RENESAS TECHNICAL UPDATE

Product Category	MPU & MCU	Document No.	TN-16C-A193A/E	Rev.	1.00
Title	Errata to R32C/151 Group Hardware Manual	Information Category	Technical Notification		
Applicable Product	R32C/151 Group	Lot No.	Reference Document	R32C/151 Group Hardware Manual Rev. 1.03 (REJ09B0503-0103)

This document describes corrections to the R32C/151 Group Hardware Manual, Rev. 1.03.
The corrections are indicated in red in the list below.

Figure 7.1 Clock Generation Circuitry

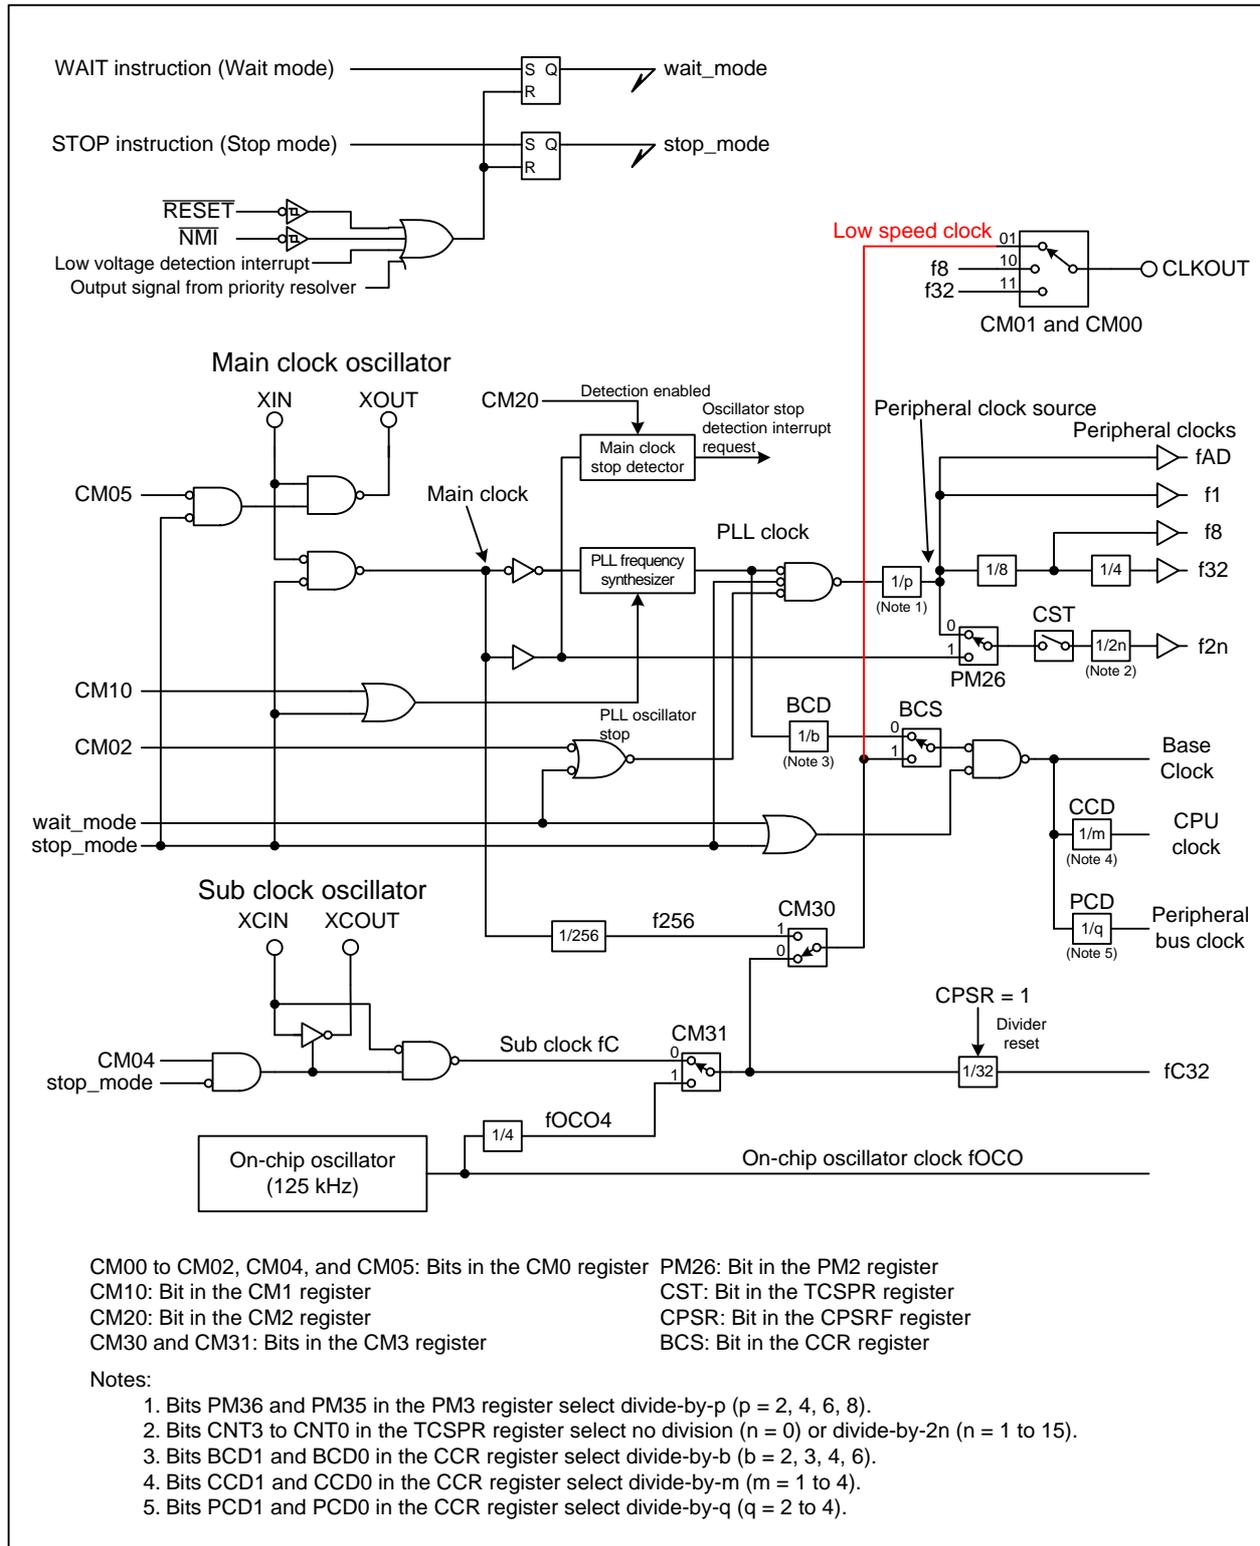
•Page 91 of 624, Figure 7.1 is corrected as follows:

Figure 7.20 State Transition (when the on-chip oscillator clock is used)

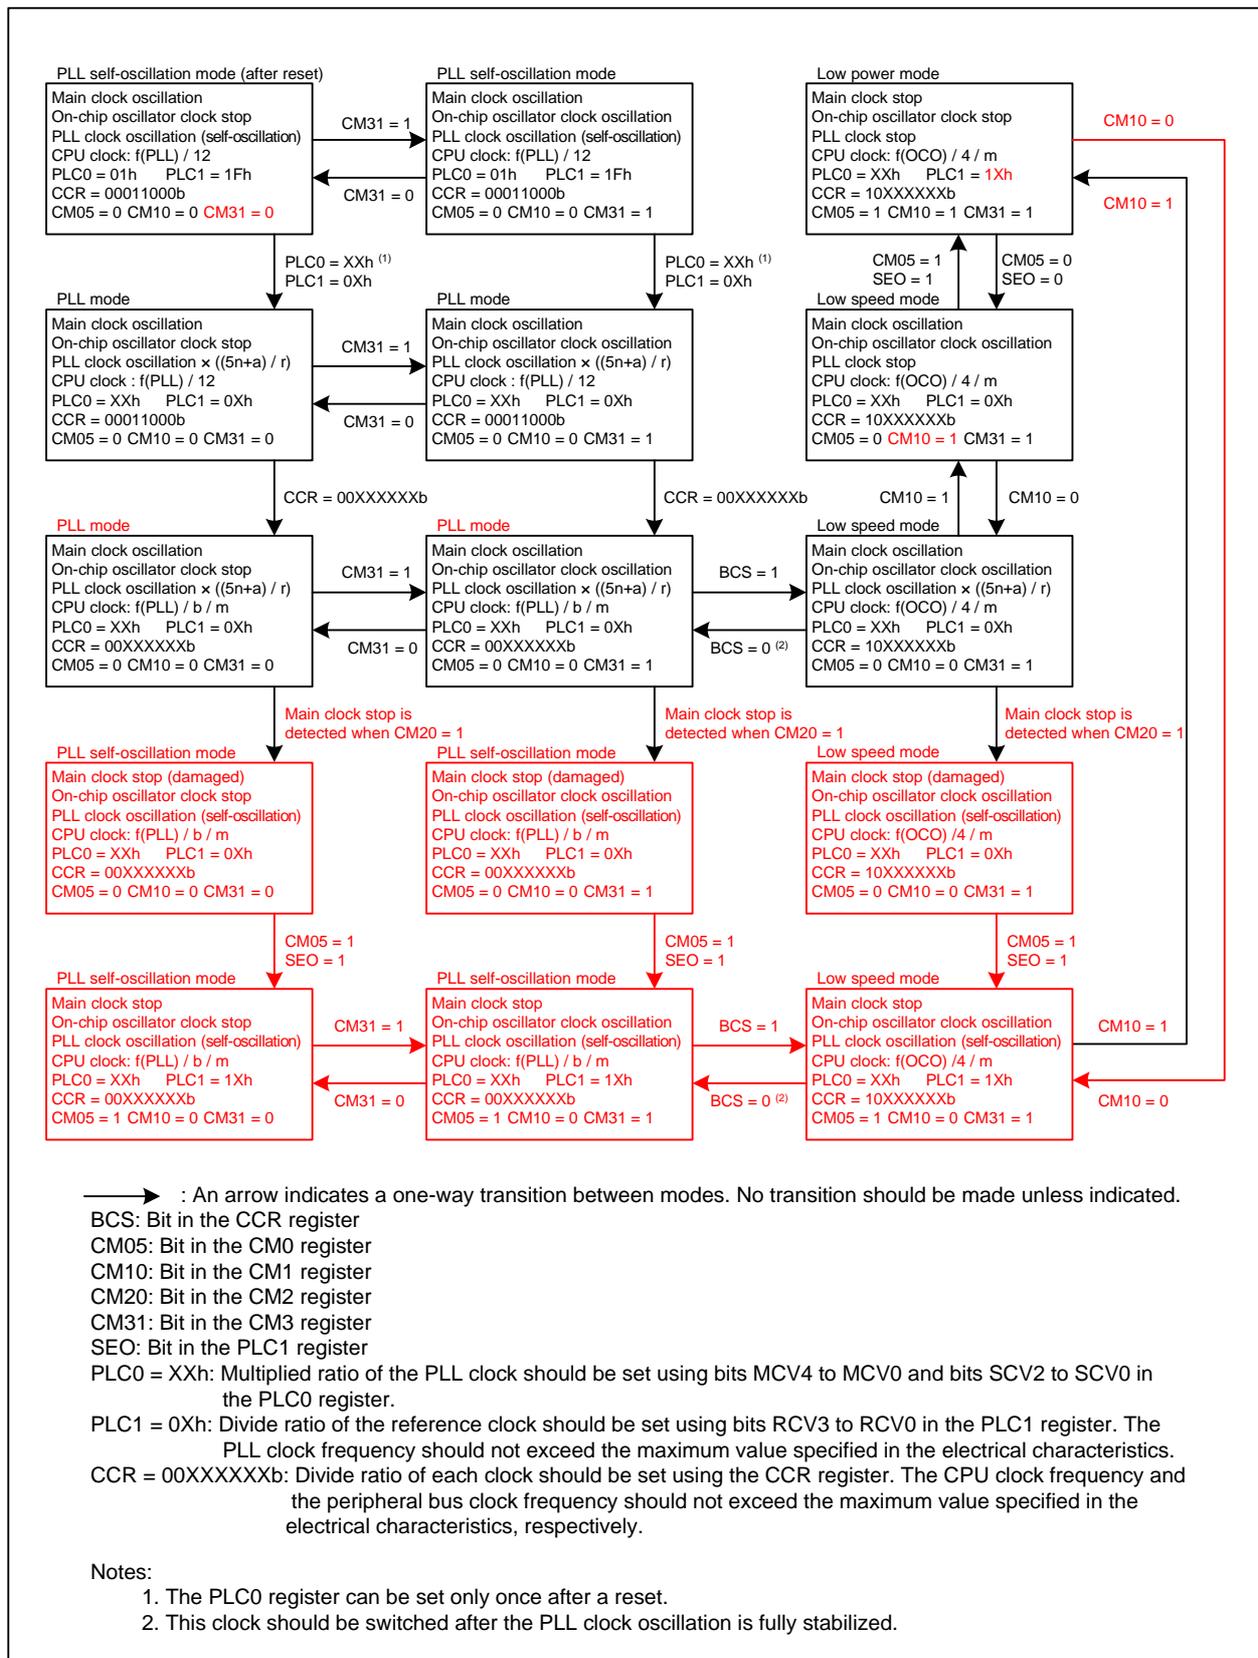
•Page 111 of 624, descriptions of “CM31 = 1” in the first row and “CM10 = 0” in the second row in Figure 7.20 are corrected, and the flowchart is clarified as follows:

(Note 3 “The CM05 bit is not set to 1 when an oscillator stop is detected through the oscillation stop detector.” is deleted from Figure 7.20)

Figure 10.8 Priority Resolver

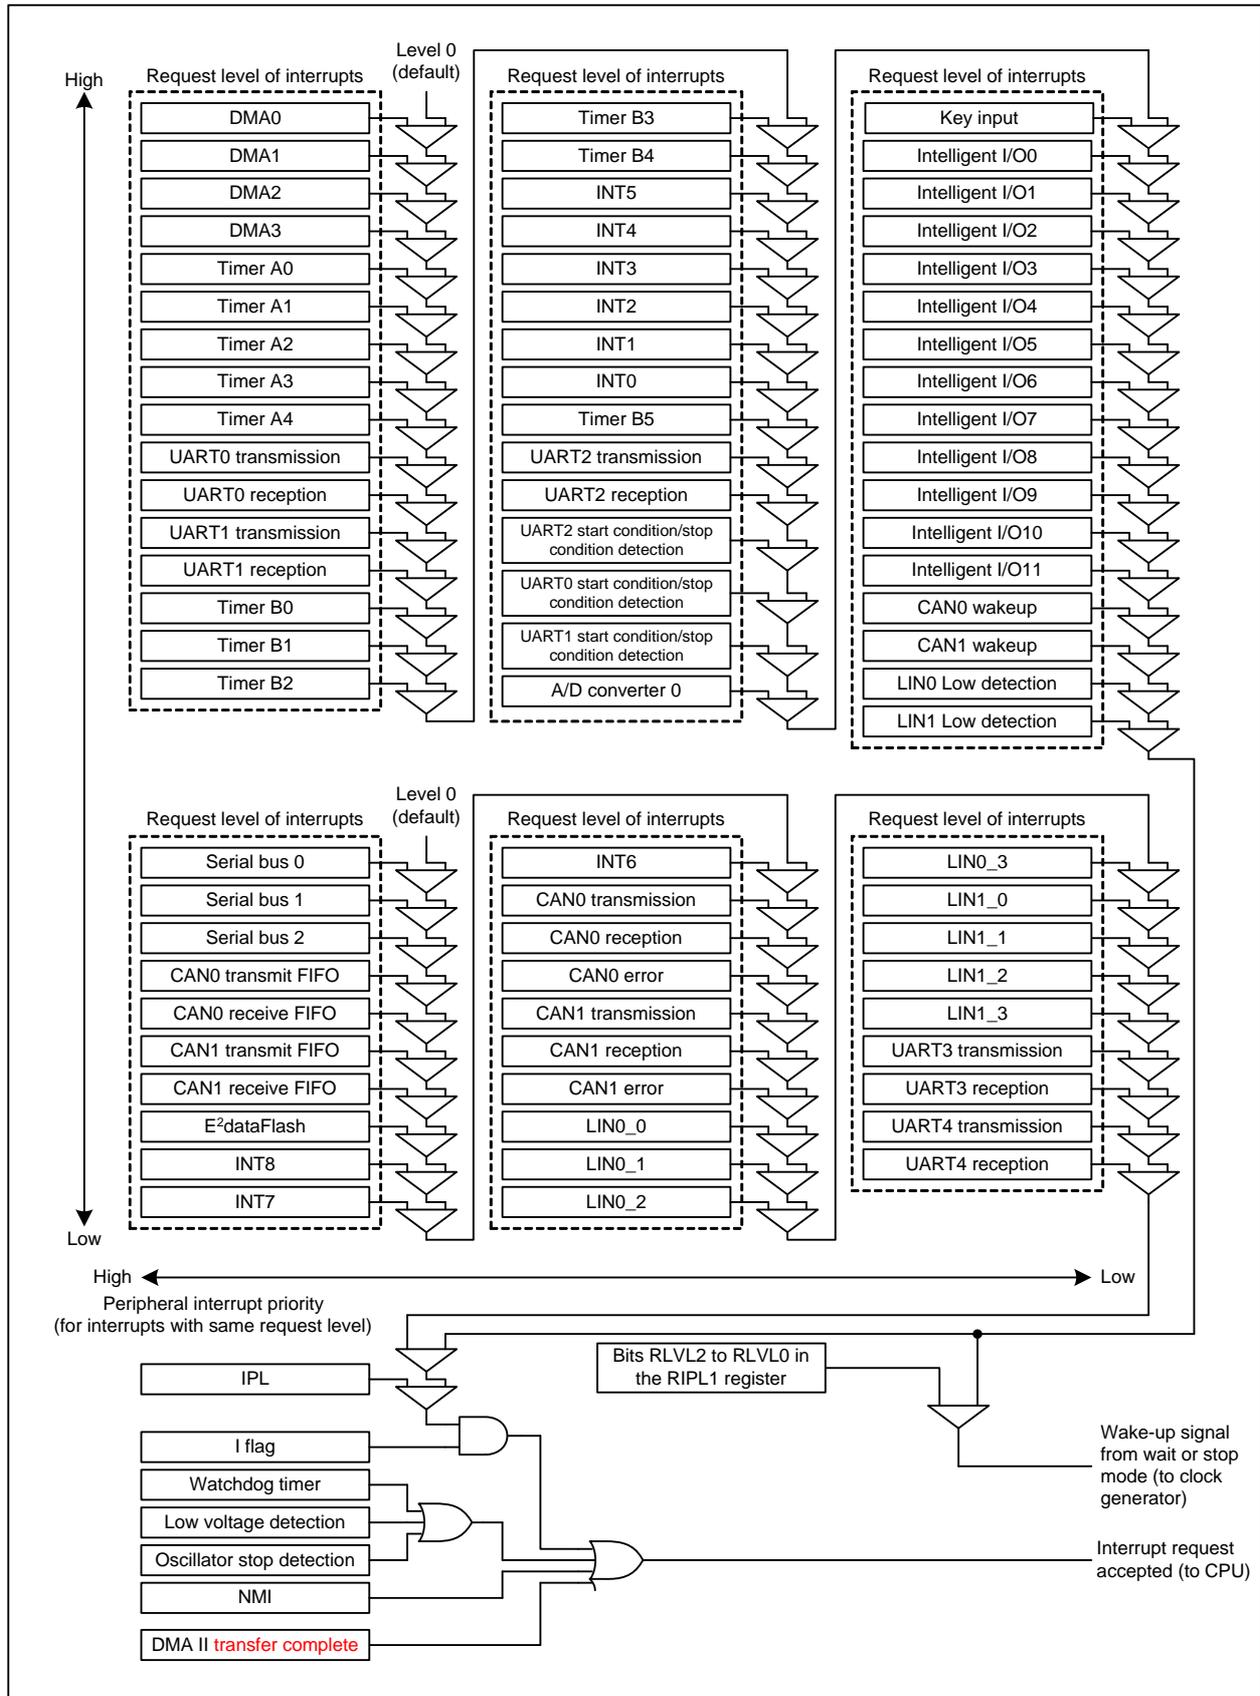
•Page 143 of 624, Figure 10.8 is corrected as follows:

(Description “Bits RLV2 to RLV0 in the RIPL2 register” and associated signal lines are deleted from Figure 10.8)

Figure 15.2 Timer B Configuration

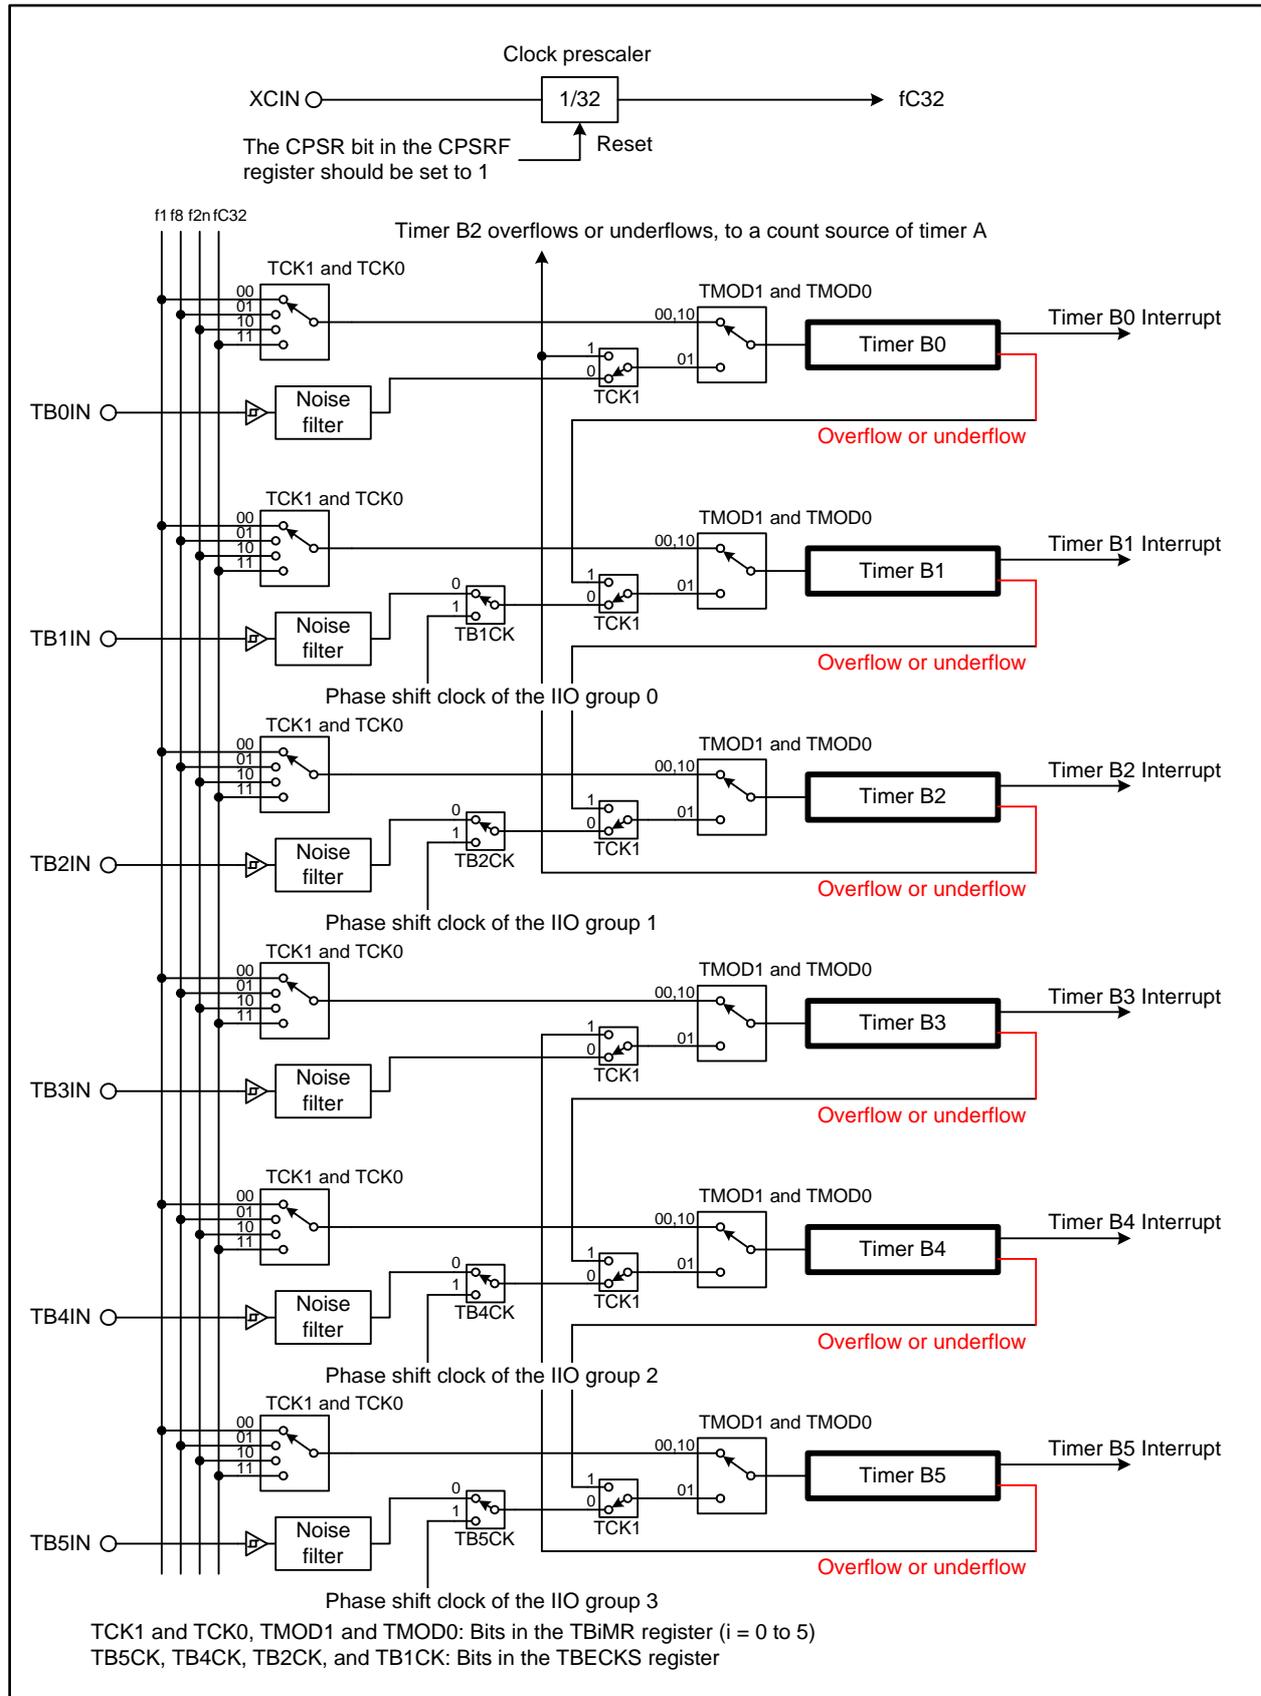
•Page 185 of 624, Figure 15.2 is corrected as follows:

Figure 24.30 Example of Setting Before Transmission to Wait Mode (i = 0, 1)

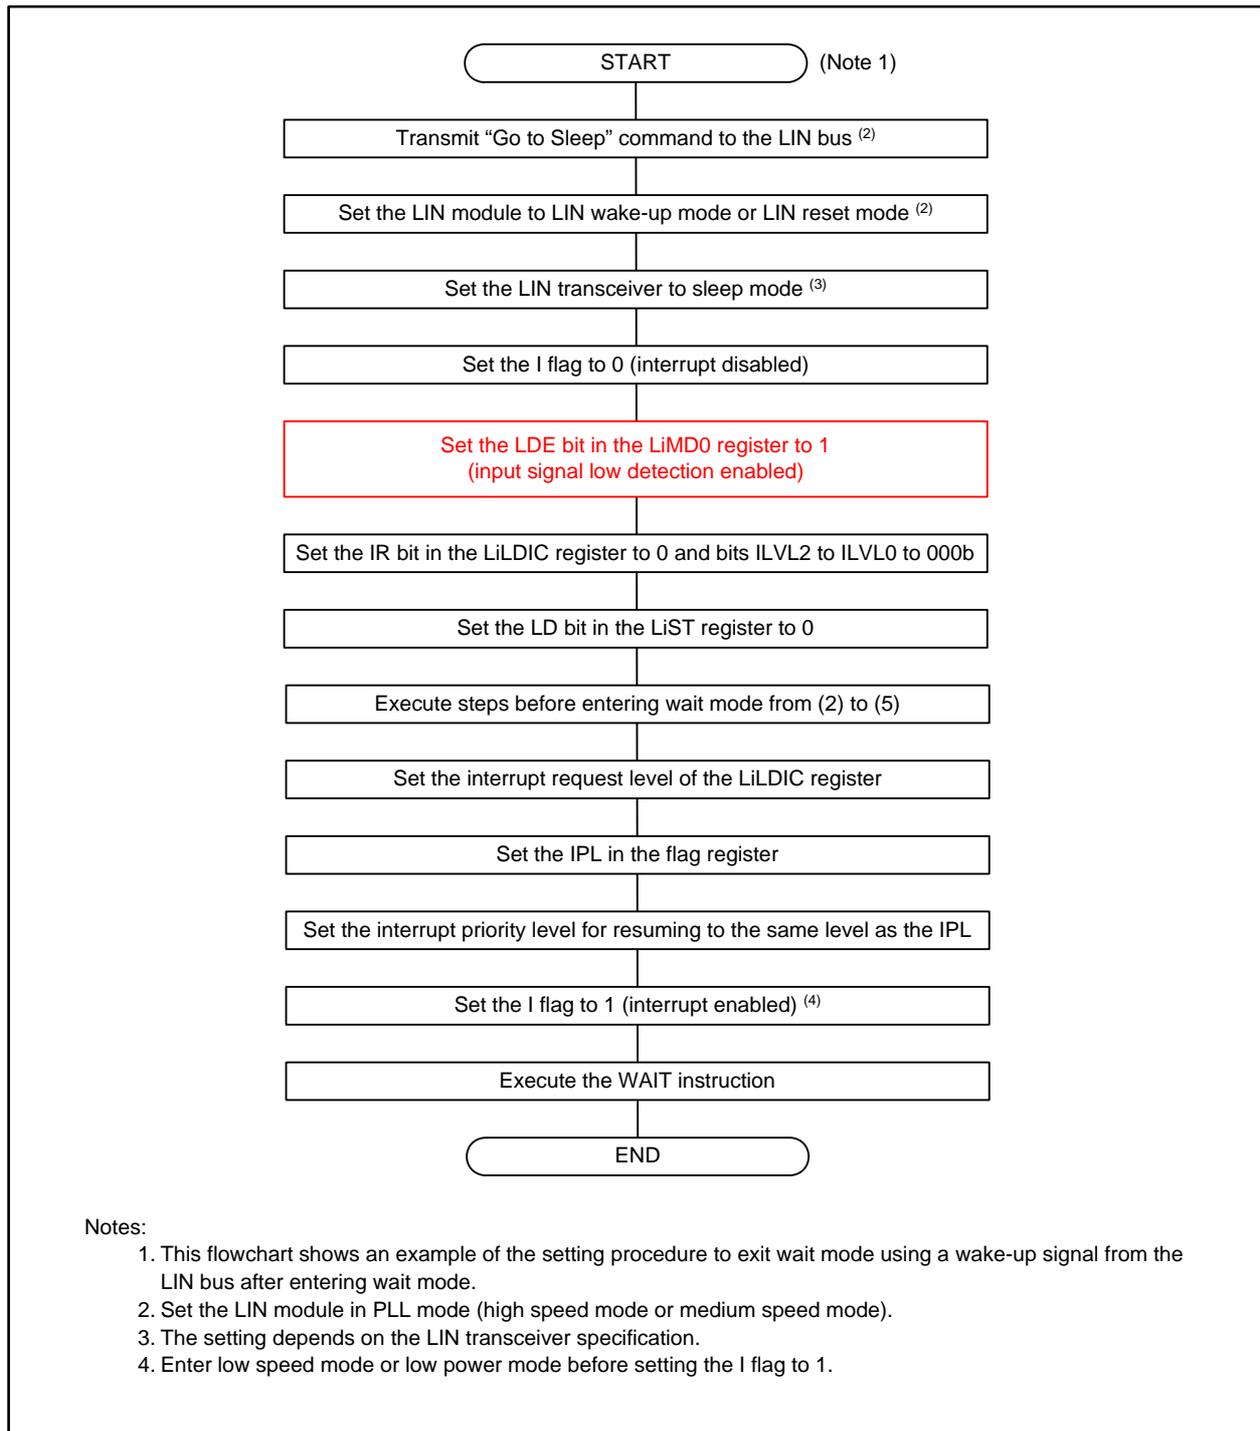
- Page 409 of 624, descriptions for (4) for “LIN Module Processing” in Table 24.5 are changed as follows:
 “Receive Data 2 due to start bit detection
 Receive Data 3 due to start bit detection
 (Repeat this process for the data length specified in bits RFDL3 to RFDL0 in the LiRFC register. Abort the reception and go to (5) if an error occurs. Checksum judgement is not performed in this case.)”
- Page 412 of 624, description “BPR0” in Note 1 of Table 24.6 is corrected as follows:
 “BRP0”
- Page 419 of 624, Figure 24.30 is corrected as follows:
